## > Product Change Notification (PCN)

<b>Product group:</b>	<b>SEMIPACK</b>	<b>Rev.:</b>	<b>0</b>
<b>No.:</b>	<b>PN19-093</b>	<b>Change of the gate bonding wire for SEMIPACK1 6th generation</b>	<b>01 Oct 2019</b>

**Subject of change:** New thyristor gate bonding wire and gate chip metallization

Gate bonding wire                      Gate chip metallization

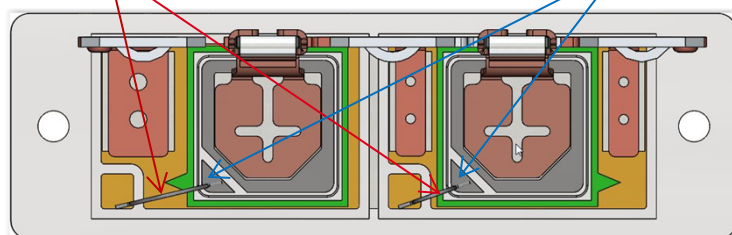
**Description of change:** Change of the gate bonding wire thickness and material:

- Current bonding wire: diameter 0,3 mm, Al
- New bonding wire: diameter 0,15 mm, Ag

Along with the gate wire the thyristor gate metallization layer will be changed from aluminium to silver terminated layer. With this change the cathode and gate area metallization will be unified.
